Proposal #06: 3170-11-70
Delavan – Lake Geneva
Lake Lawn to STH 67
STH 050
Walworth County

This is Addendum No. 01, which provides for the following:

ADDENDUM NO. 01

Addendum No. 01
ID 3170-11-70
Revised Sheet 15
June 3, 2025

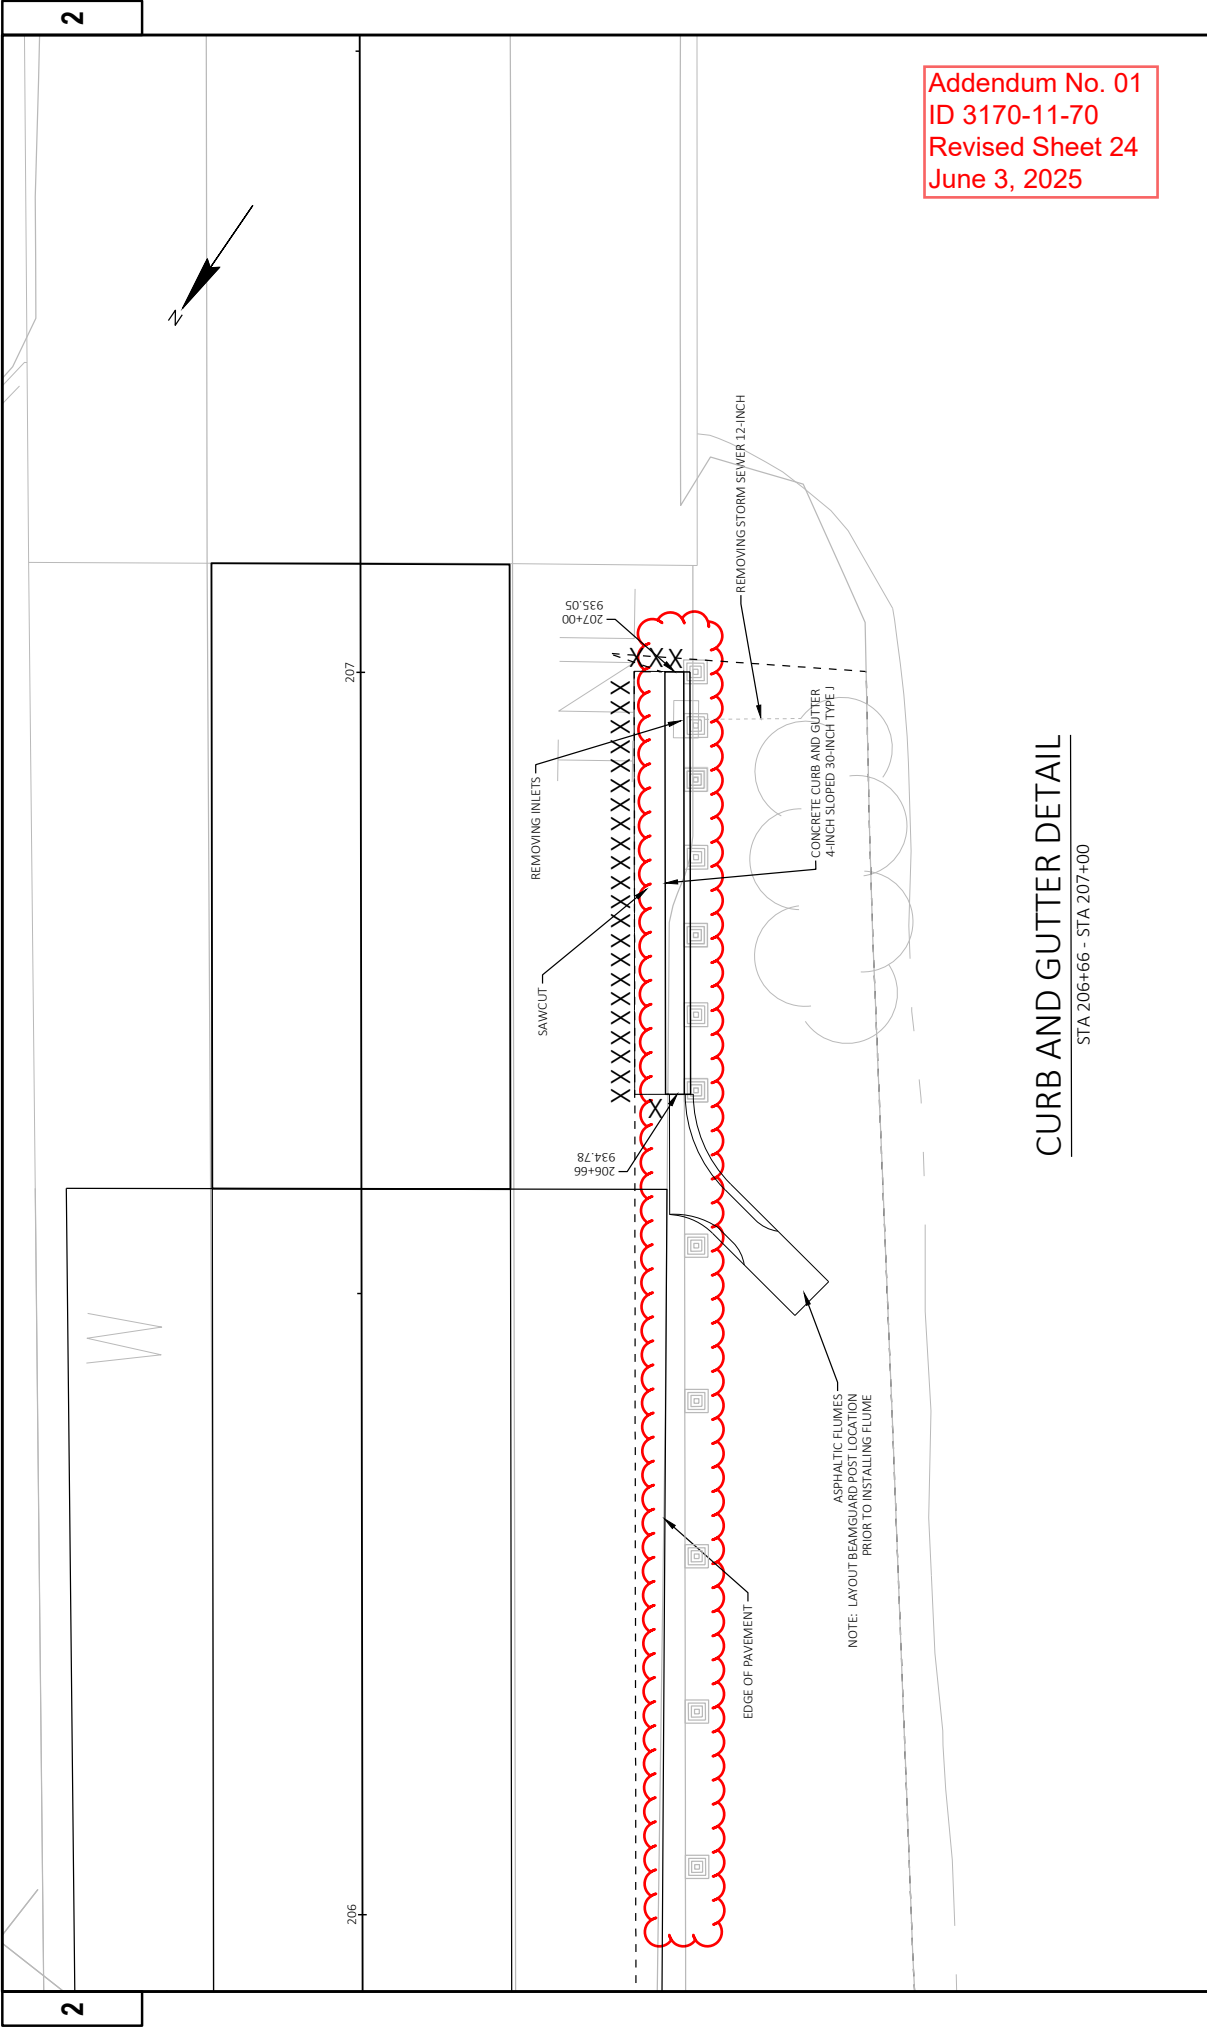
Revised Plan Sheets	
Plan Sheet	Plan Sheet Title (brief description of changes to sheet)
15	Construction Details - Revised Wall Modular Block Gravity Landscape pay limits
24	Construction Details - Revised curb and gutter detail to show guardrail correctly
32	Plan Details – Added offset distance to the MGS EAT, Guardrail, and Thrie Beam
212	Miscellaneous Quantities– Revised quantity for Wall Modular Block Gravity Landscape
